Author's response

The authors present an interesting study on the characteristics of failed lakes in Patagonia and, on this basis, on the susceptibility of glacial lakes in the Baker Basin, to GLOFs. Most of the manuscript is concise, well-written and well-structured. I can recommend the work for publication after the authors have included some **minor-moderate revisions** specified in detail below.

Figure 2. Location of moraine-dammed lakes and settlements in the Baker Basin.

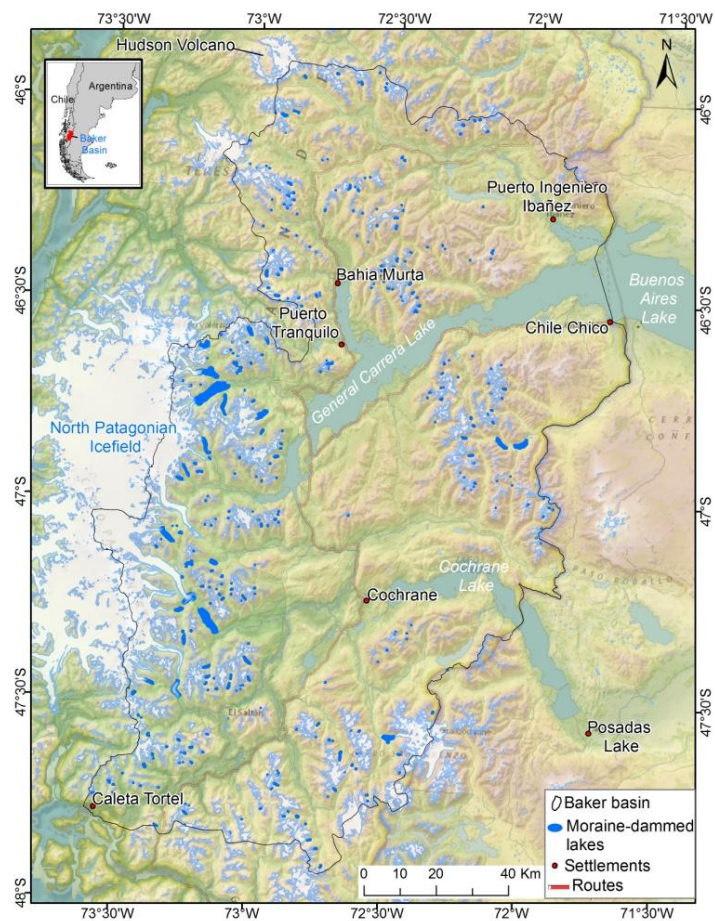
1. The quality of the figures is generally very good. It might be useful for the reader to have an overview map of the Baker Basin presented early in the paper (a map of the basin is only shown in Fig. 12 where the results are presented). In contrast, Fig. 8 could be omitted – in my opinion, it does not carry a lot of additional information.

-We agree with the referee comment and will incorporate an overview map of the Baker Basin early in the paper (see the figure at the end of this response). We considered also removing the figure 8, however, we think that it has a value as a graphical synthesis of failed moraine-dammed lake settings in Patagonia and we prefer to keep it.
